APPLICATION FOR PERMIT TO DRILL				5. MINERAL LEASE NO: ML-48757	6. SURFACE: State
1A. TYPE OF WORK: DRILL <input checked="" type="checkbox"/> REENTER <input type="checkbox"/> DEEPEN <input type="checkbox"/>				7. IF INDIAN, ALLOTTEE OR TRIBE NAME:

2. NAME OF OPERATOR: WESTPORT OIL & GAS COMPANY, L.P.				9. WELL NAME and NUMBER: STATE 920-36N	
3. ADDRESS OF OPERATOR: 1368 S 1200 E CITY VERNAL STATE UT ZIP 84078				PHONE NUMBER: (435) 781-7060	10. FIELD AND POOL, OR WILDCAT: NATURAL BUTTES

API NUMBER ASSIGNED: 43-047-36858

**DIVISION OF OIL, GAS AND MINING
APPLICATION FOR PERMIT TO DRILL
STATEMENT OF BASIS**

Casing Schematic

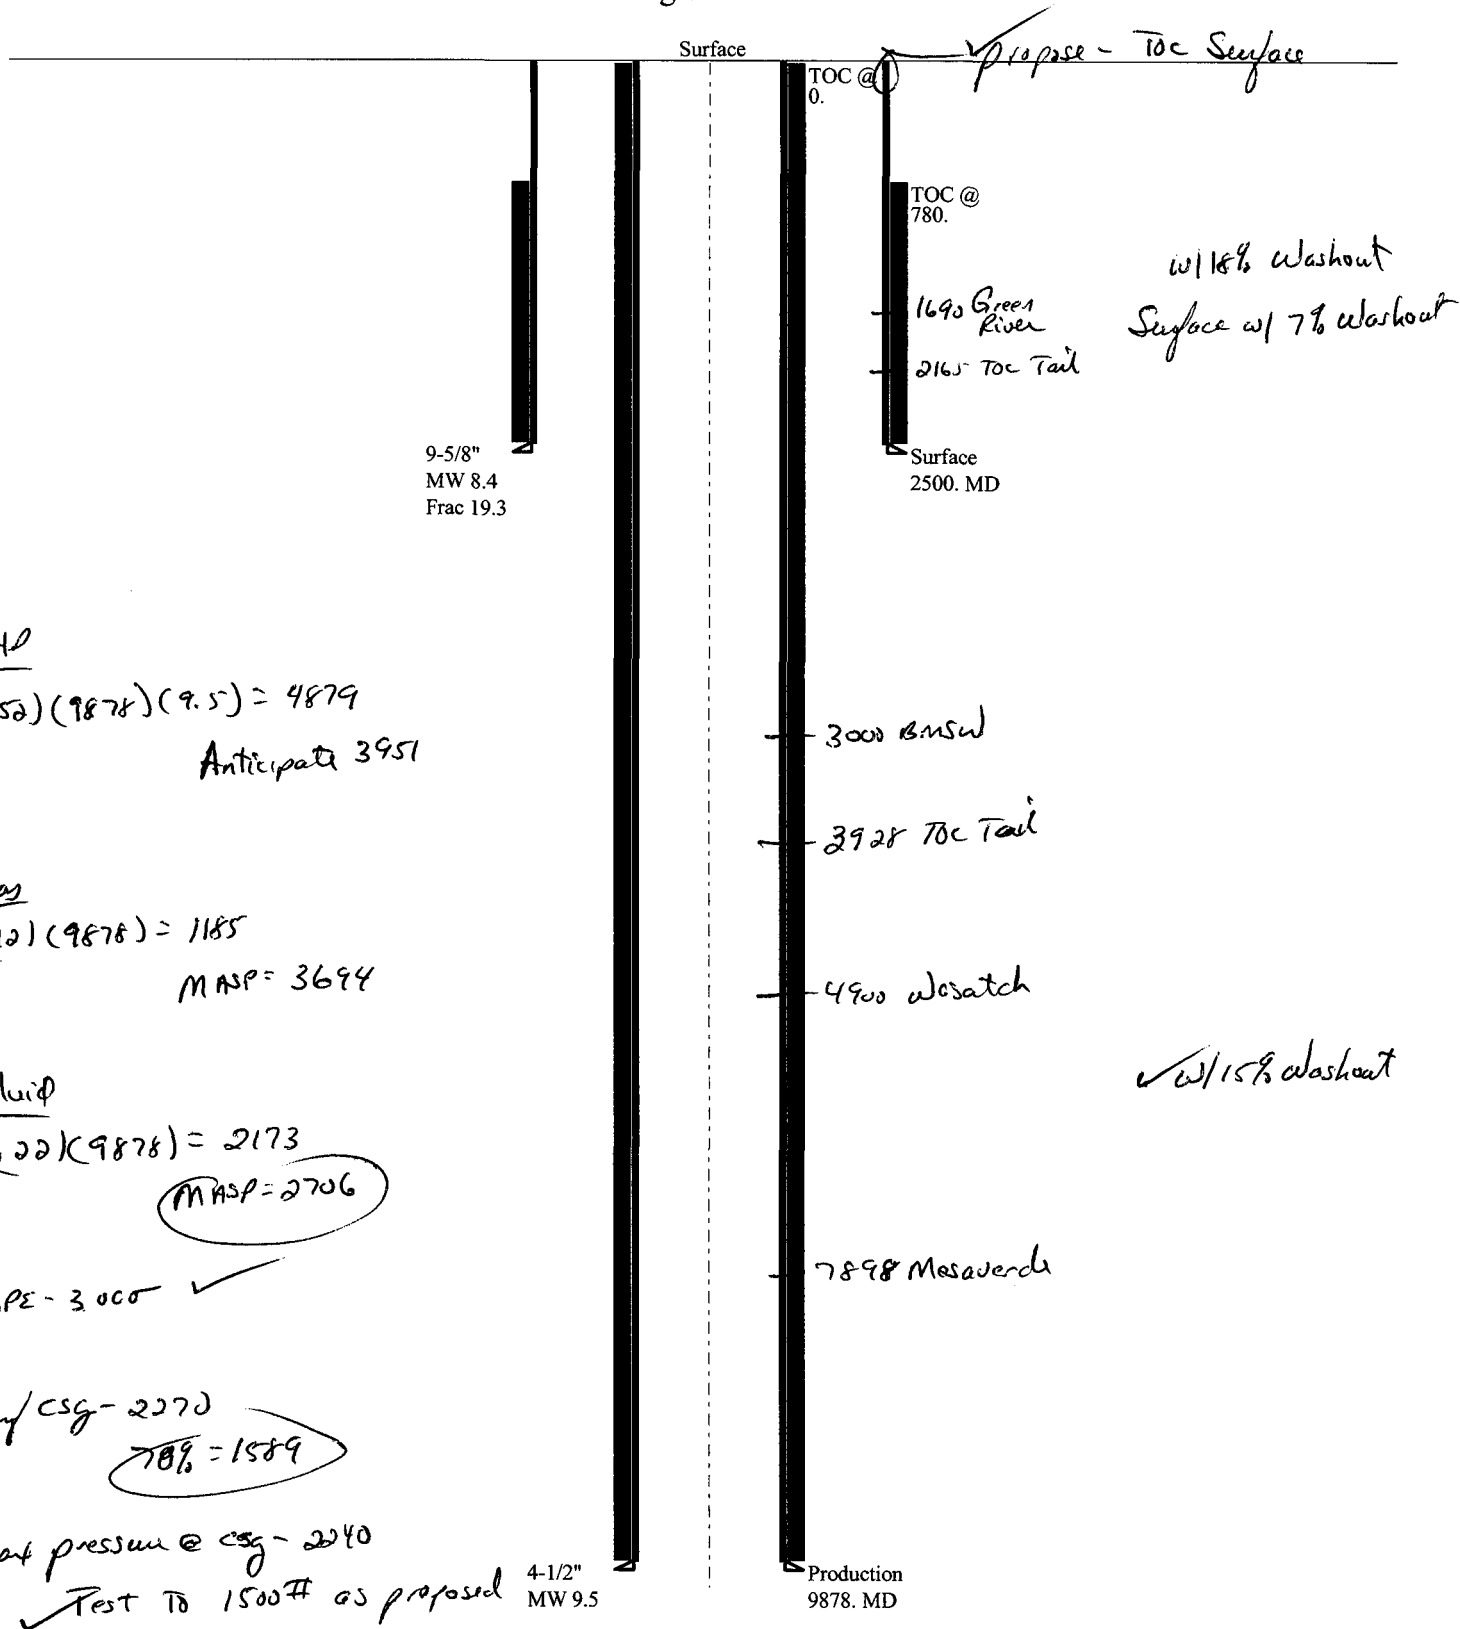
BHP

$$(0.052)(9878)(9.5) = 4879$$

Anticipate 3951

Gas

$$(0.12)(9878) = 1185$$

MAWP = 3694

Fluid

$$(0.22)(9878) = 2173$$

MAWP = 2706

BOPE - 3000 ✓

Surf CSG - 2270

70% = 1589

Max pressure @ CSG - 2240

Test to 1500# as proposed
